Proposal: Land at Farleigh Farm and 54 and 56 Farleigh road, Backwell

Planning Reference:21/P/1766/OUT

Further to the response received from Simon Bunn on the 7th January 2022 we have reviewed the detailed points raised and set out below our response to them. The key points noted are —

Discharge Location

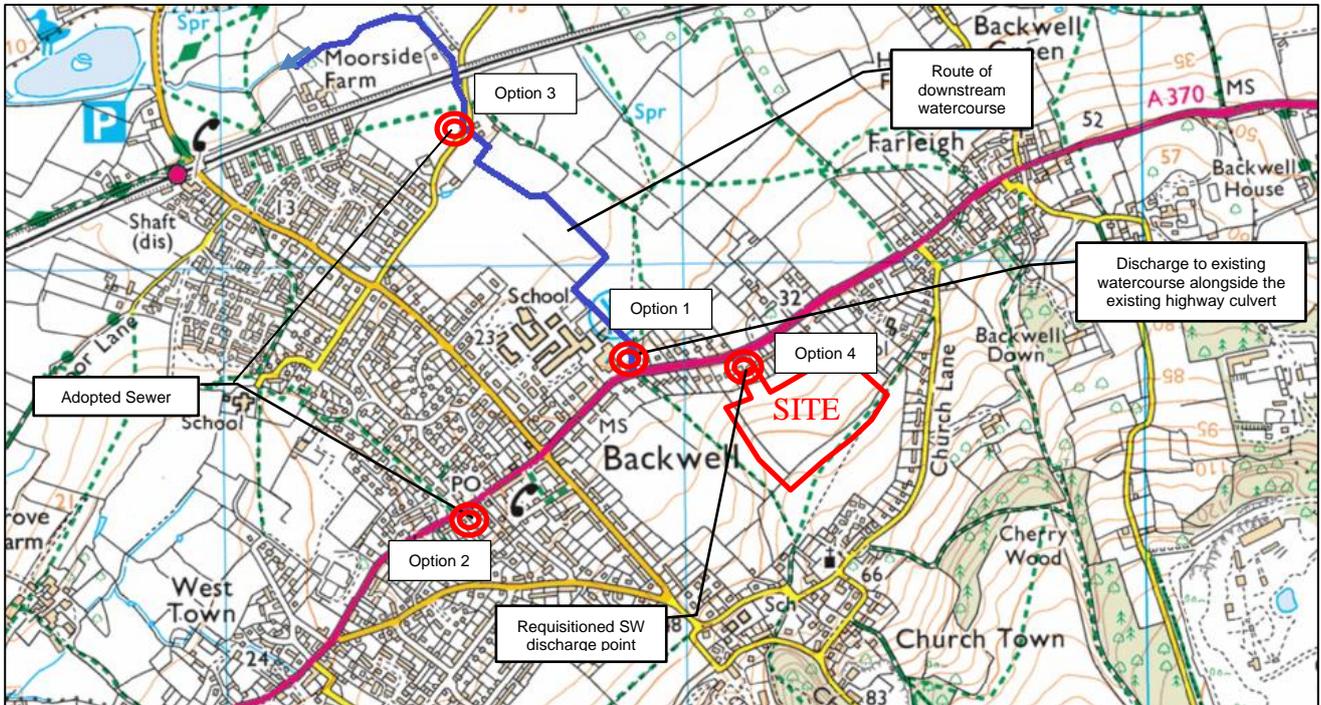
The discharge location requiring a survey of the condition and capacity was something which was previously agreed to be conditioned on the earlier application. Whilst the ditch alongside the leisure centre is the preferred option offered in the outline there are other options which are all viable to Wessex Water. The alternative options although located further away are site viable options for the scheme. We agree an assessment of the condition and capacity of the ditch system will be required but this is considered something which could be conditioned as this will involve the detailed design of systems, headwalls, levels etc... subject to the findings of the preferred option to connect to the ditch the alternative options are still also available.

To help clarify the outfall options the locations of all the options of surface water disposal are shown on the below plan. A final choice of outfall will be determined after approval of the outline application. The options currently identified are:

1. Discharge into the existing ditch on the east side of the Backwell Leisure Centre. The Farleigh Rd highway drain discharges into this ditch through a 300mm diameter pipe, and the ditch currently receives run-off flows from the site which flow onto the road. North Somerset Council previously agreed to the discharge into the ditch to be conditional upon satisfactory capacity and future maintenance arrangements.

2. Discharge to an adopted surface water sewer in West Town Rd at the junction with Rodney Rd. WW have confirmed that they will accept greenfield flows from the site into this sewer. This route is downstream and can drain via gravity so would not require the use of a pump.

3. Discharge into an existing adopted surface water sewer in Backwell Common Rd. WW has confirmed that they will accept flows into this sewer.
4. Requisition a new surface water discharge point on the site from WW in accordance with S98 of the Water Industry Act 1991.
